CITY OF WEST LAKE HILLS, TEXAS
NOTICE OF CITY COUNCIL REGULAR MEETING
Wednesday, October 9, 2024 at 7:00 PM

8. Administration Discuss and consider action to approve change order number 1 for the FY24 Street Maintenance project with Alpha Paving and authorize the City Administrator to execute the same.

FY24 Street Maintenance Program

X:\02\2023\23011-00 2023-2024 Street Rehab and Drainage\3-Production\03-Sheets\02-23011-00-PVMT - WESTLAKE DRIVE.dwg
Jun 12, 2024 - 5:12pm

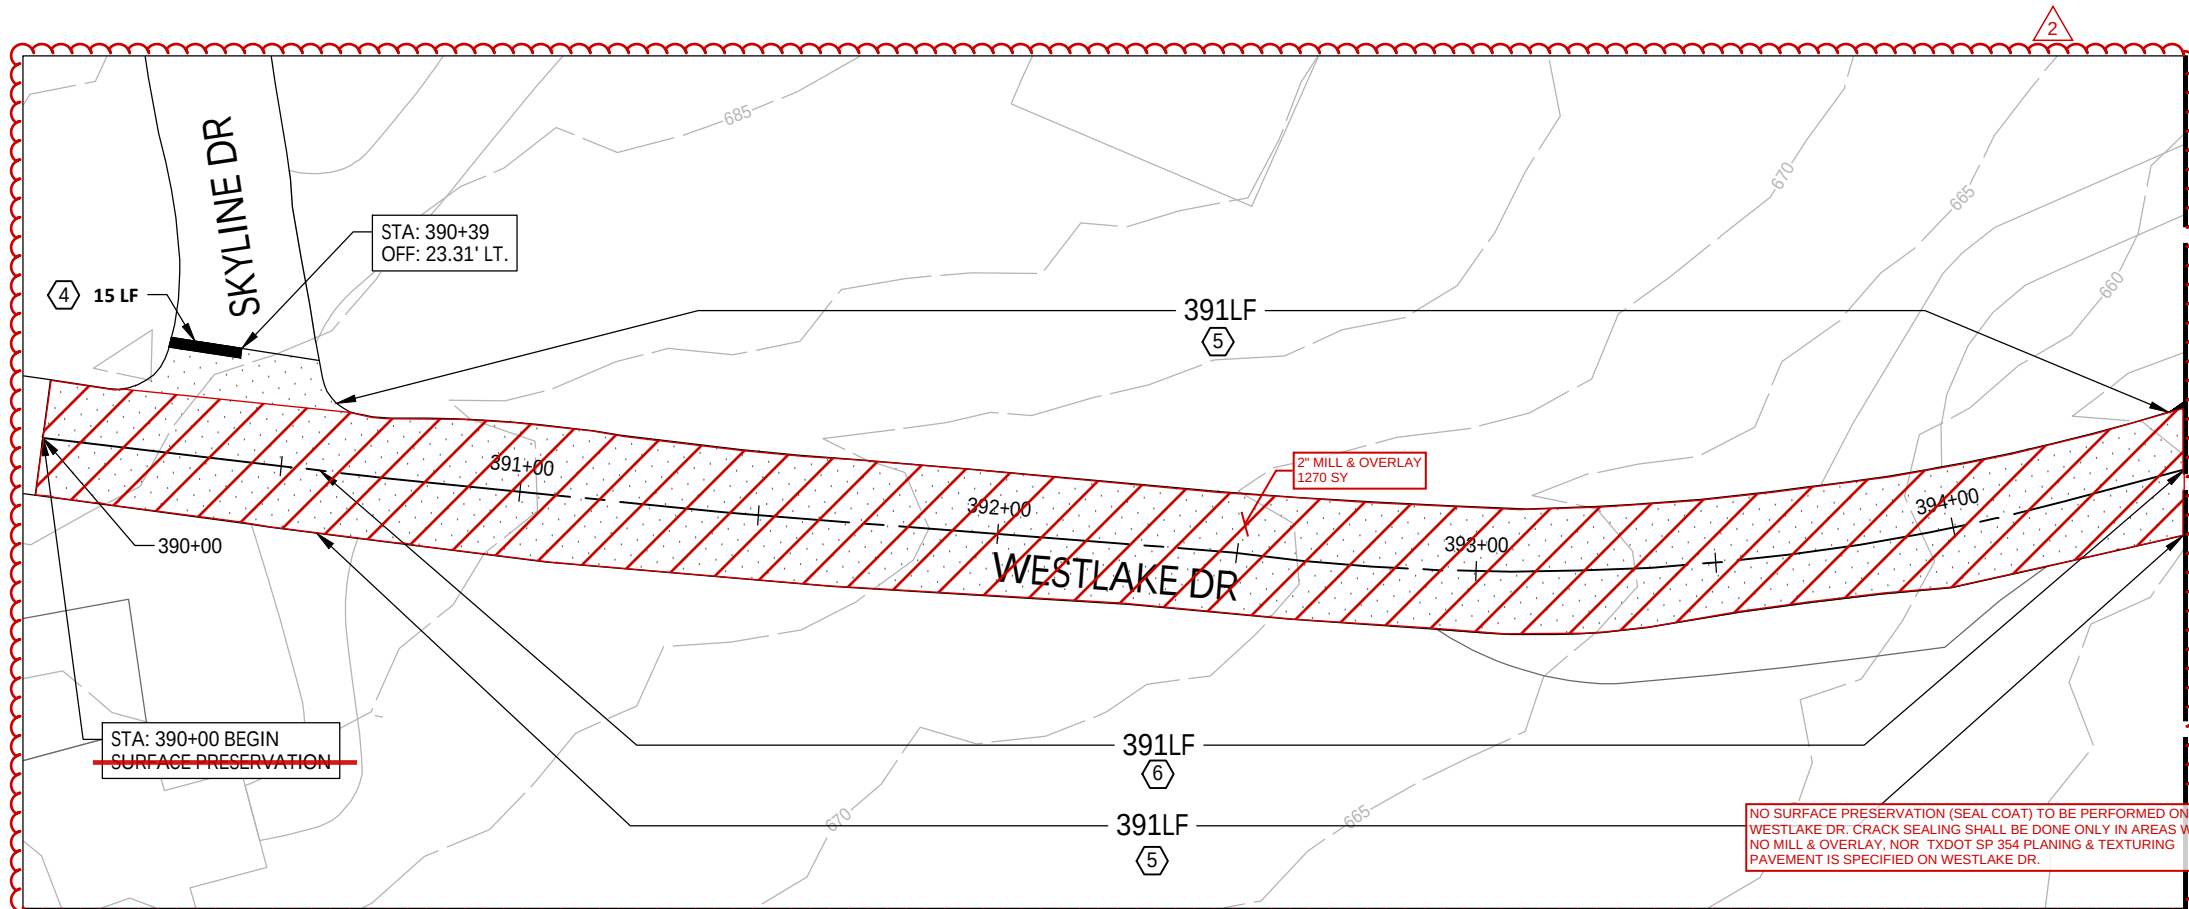
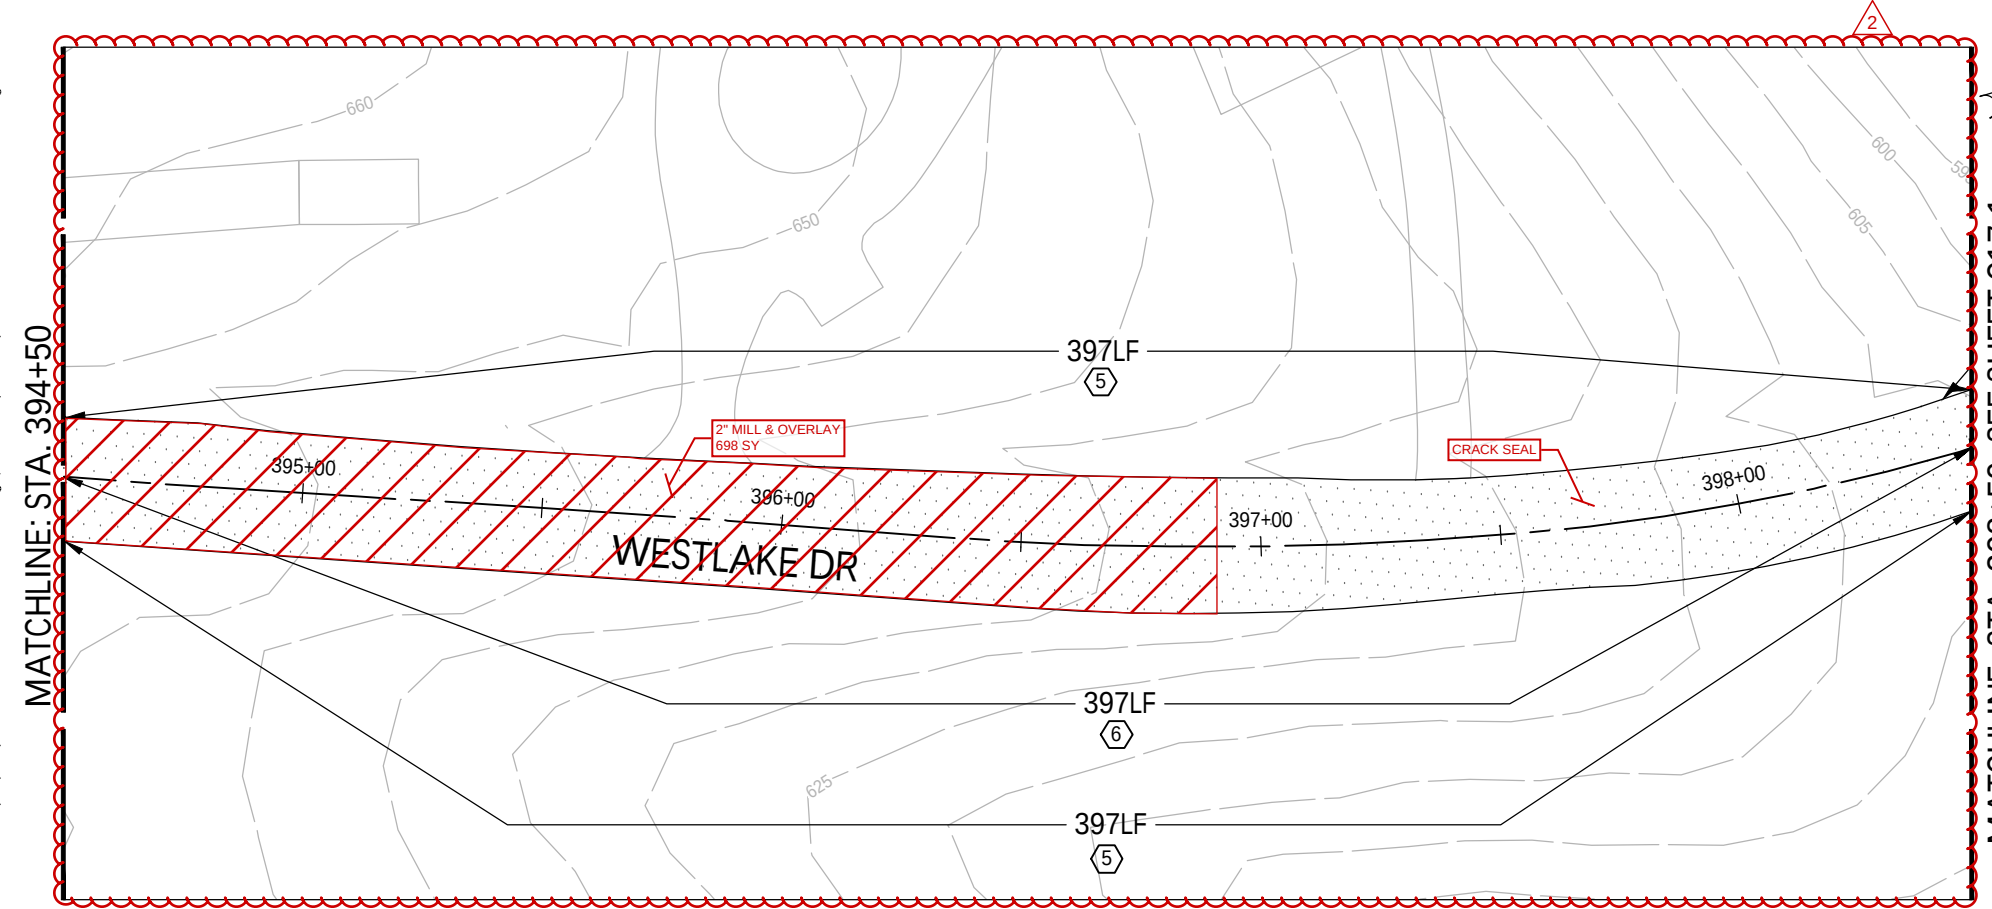
STA: 314+19 END
~~SURFACE PRESERVATION~~
MILL & OVERLAY

NO SURFACE PRESERVATION (SEAL COAT) TO BE PERFORMED ON WESTLAKE DR. CRACK SEALING SHALL BE DONE ONLY IN AREAS WHERE NO MILL & OVERLAY, NOR TXDOT SP 354 PLANING & TEXTURING PAVEMENT IS SPECIFIED ON WESTLAKE DR.

C26.2

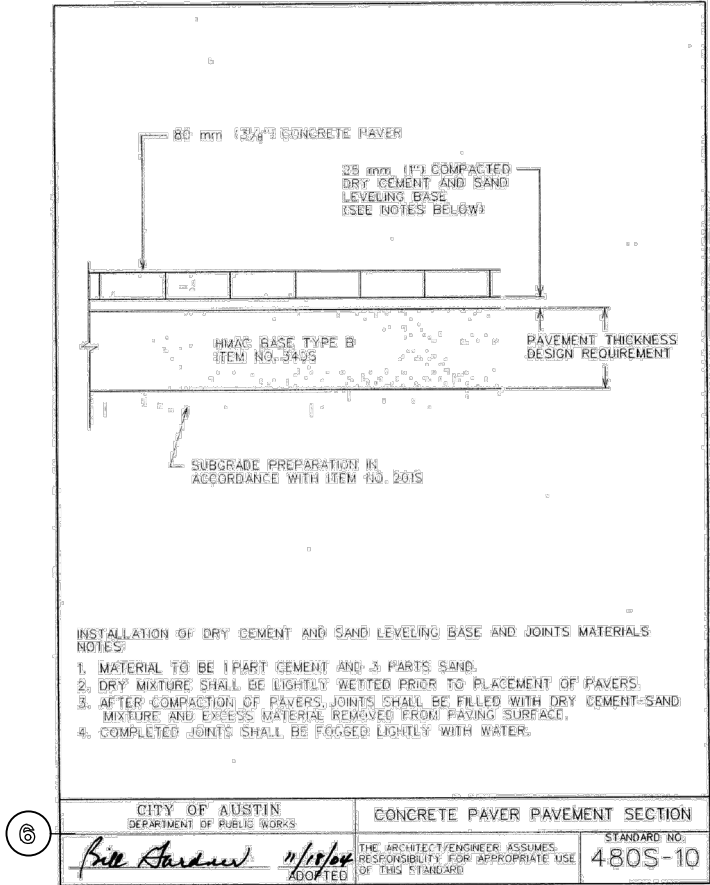
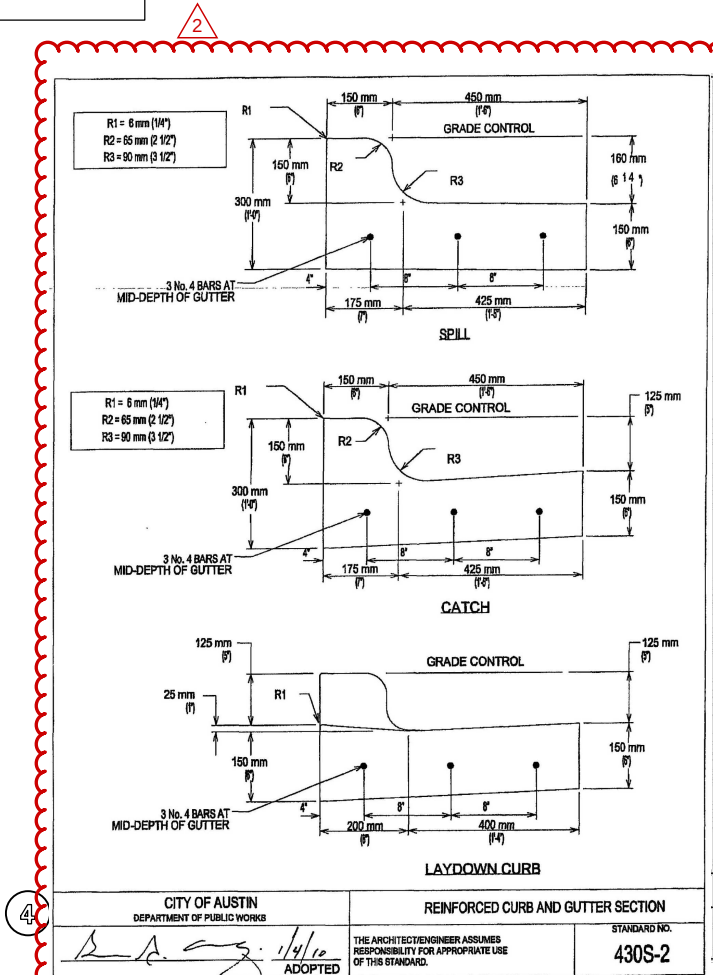
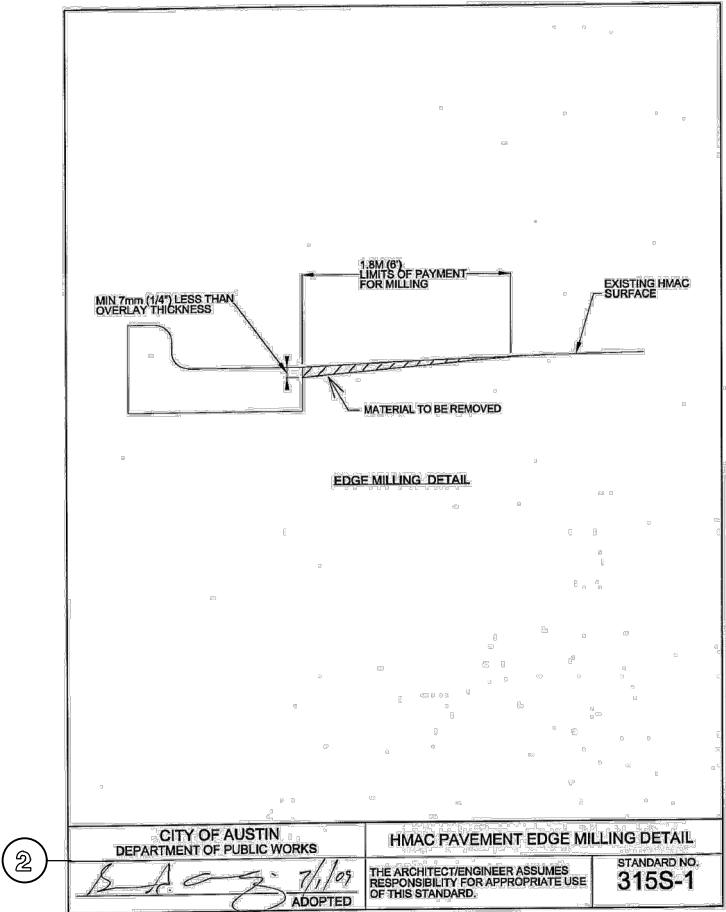
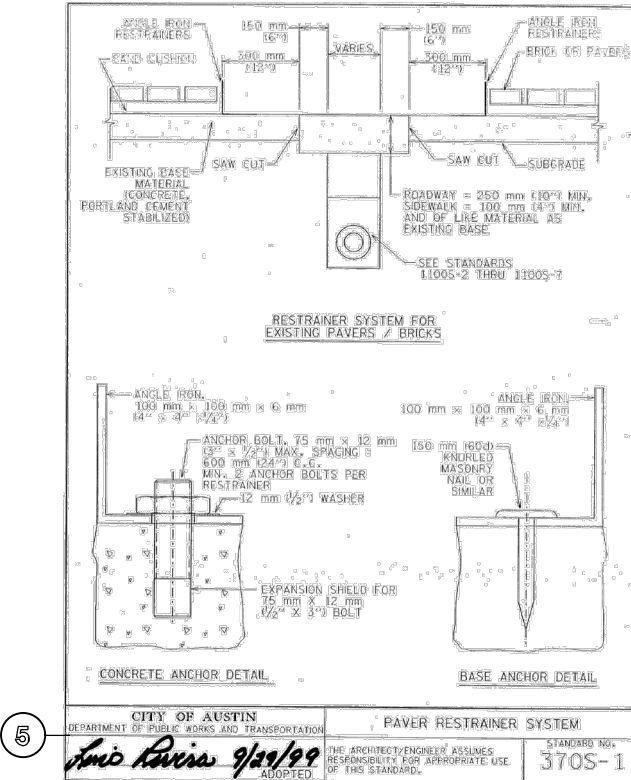
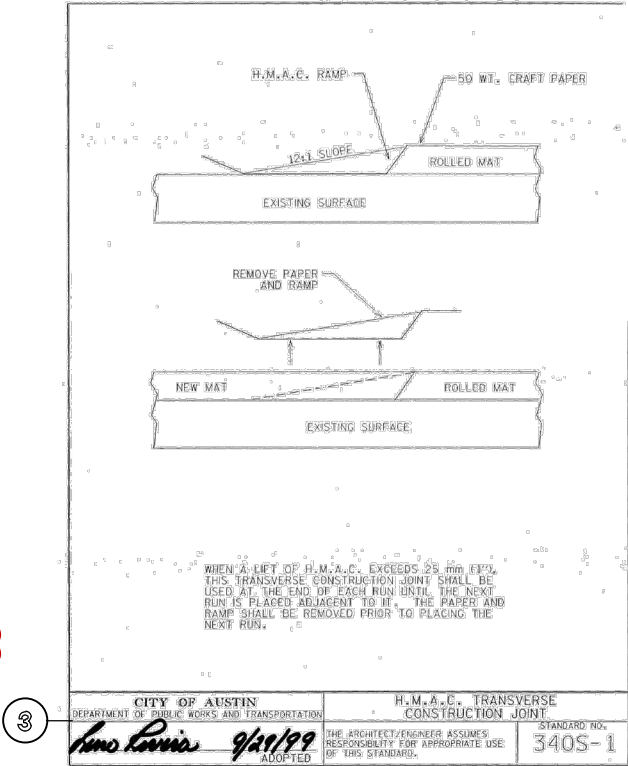
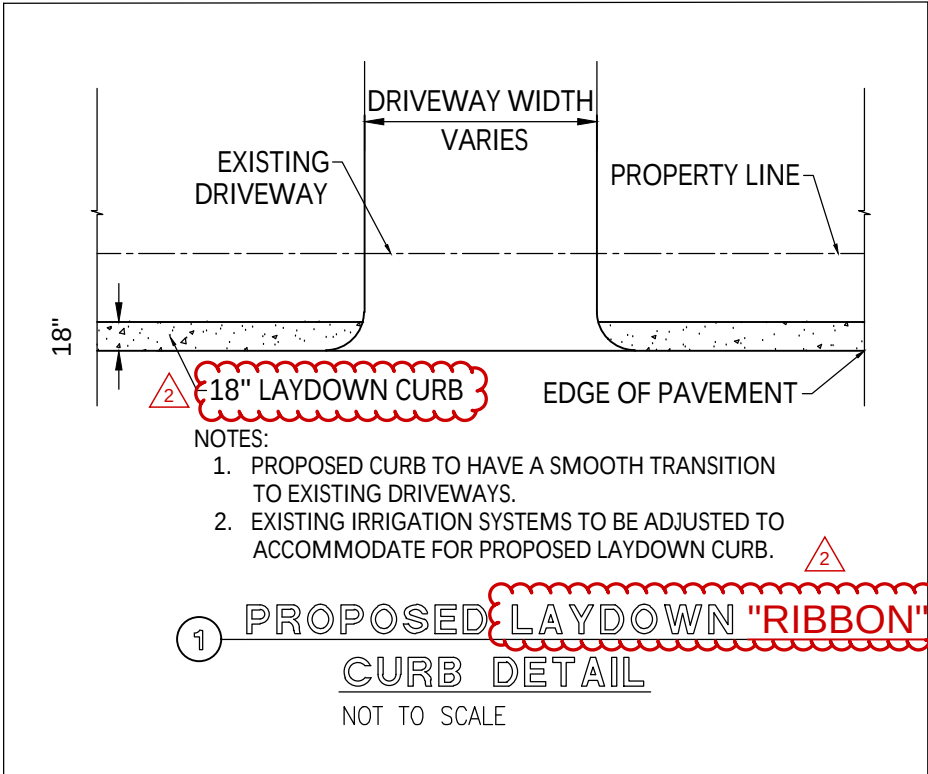
LAYDOWN "RIBBON" CURB BEDDING MATERIAL TO EXTEND A MINIMUM OF 1' FROM EDGE OF CURB.
